TOWNSHIP OF VERONA
BOARD OF ADJUSTMENT APPLICATION

CASE # 2025-05

PROPERTY ADDRESS 40 Elmwood Road, Verona, NJ 07044

Zoning Permit Application #2025-058 – DENIED - Addition, Deck/Landing/Steps

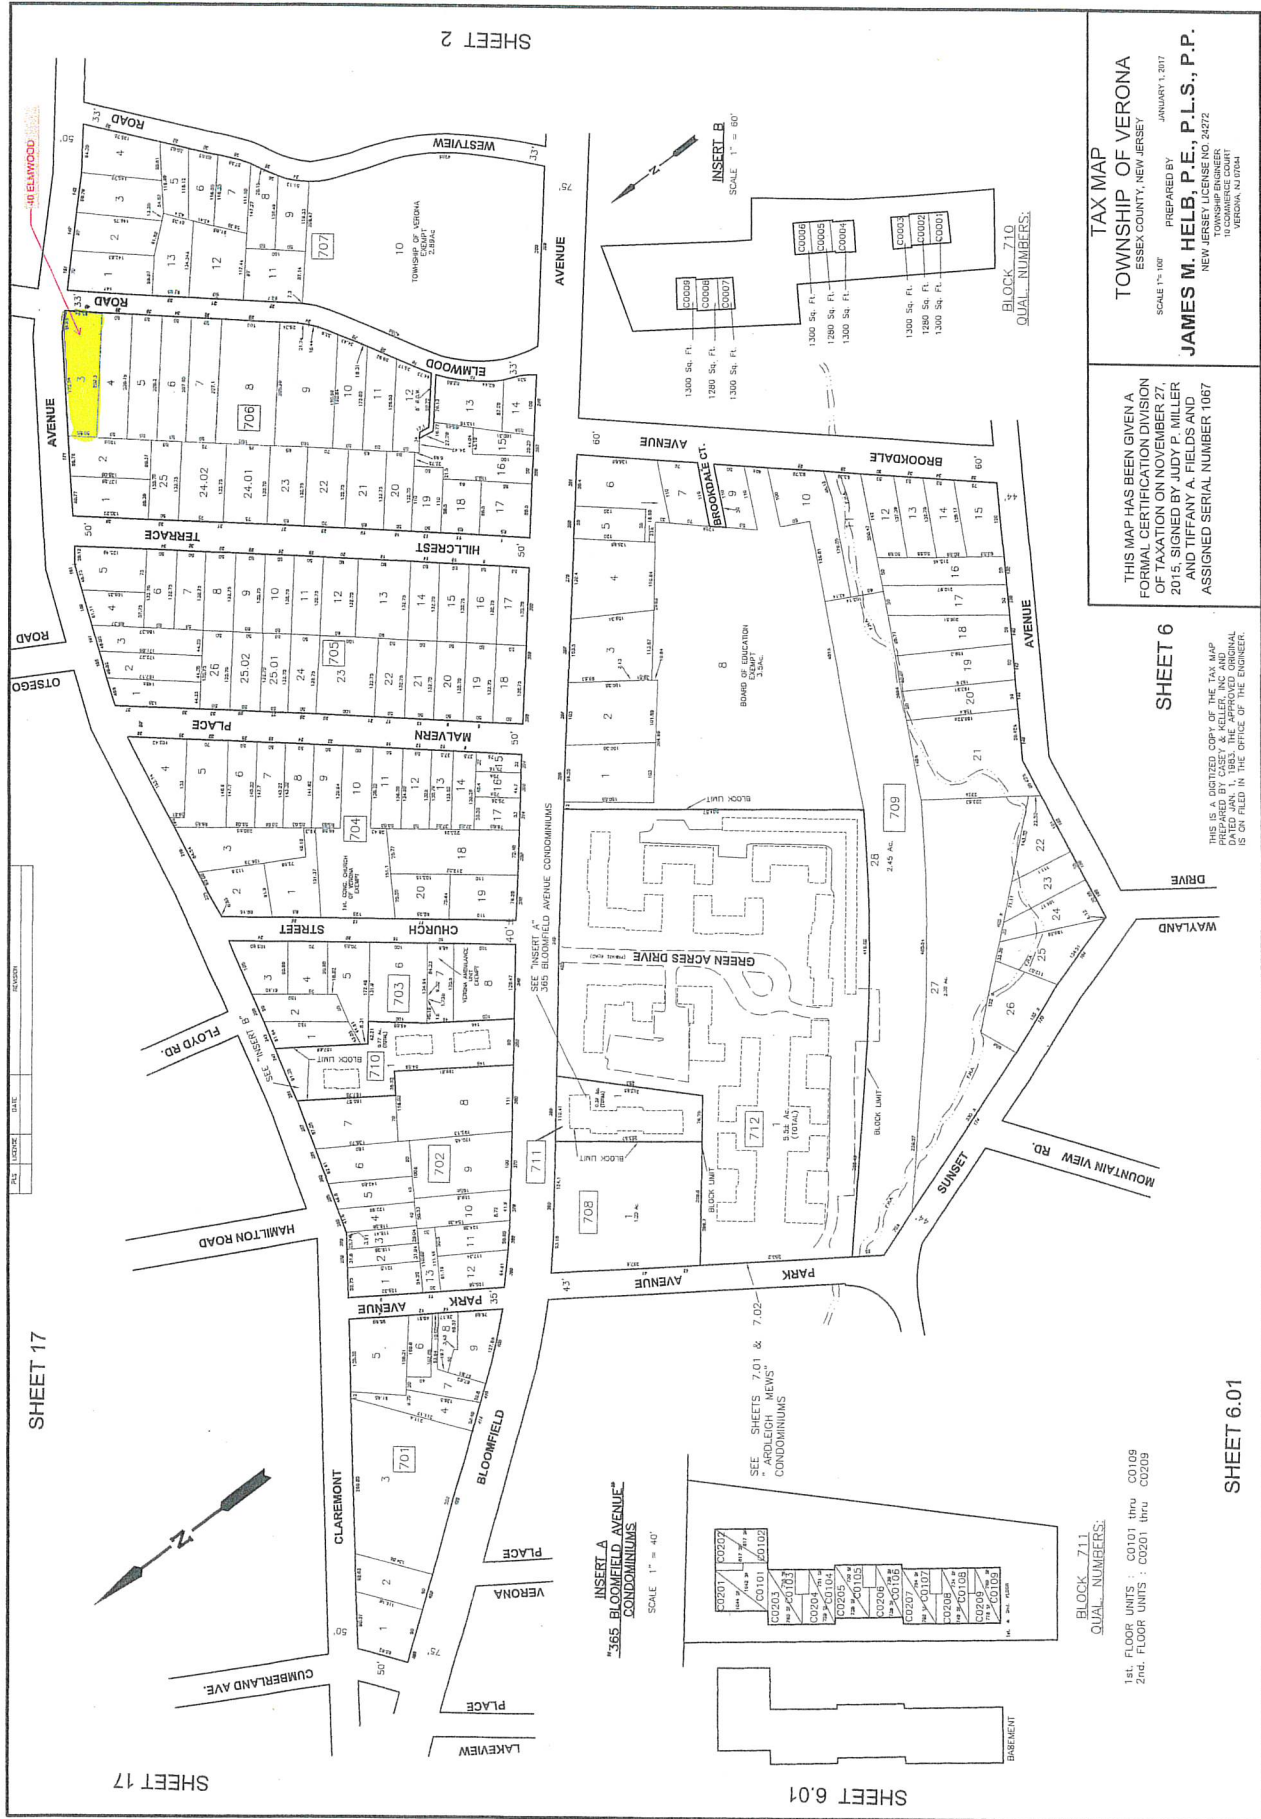
- Existing on the Elmwood Road 47 feet with no proposed change;
 - Existing on the Claremont Avenue frontage is 18 feet 4 ½ inches; proposed on the Claremont Avenue frontage is 16' 1" – **A variance is required;**

- As per § 150-17.4 F. (4) Maximum aggregate area covered by accessory structures in the yard it is located in: 15%. Rear yard shows as 4,590 square feet measured from the last wall of the proposed dwelling addition; 15% is 688.50 square feet; proposed is 24% or 1111.75 square feet - **A Variance is required:**

Based on the reviewed submitted items, the applicant's request for a Zoning Permit has been **DENIED** by this office.
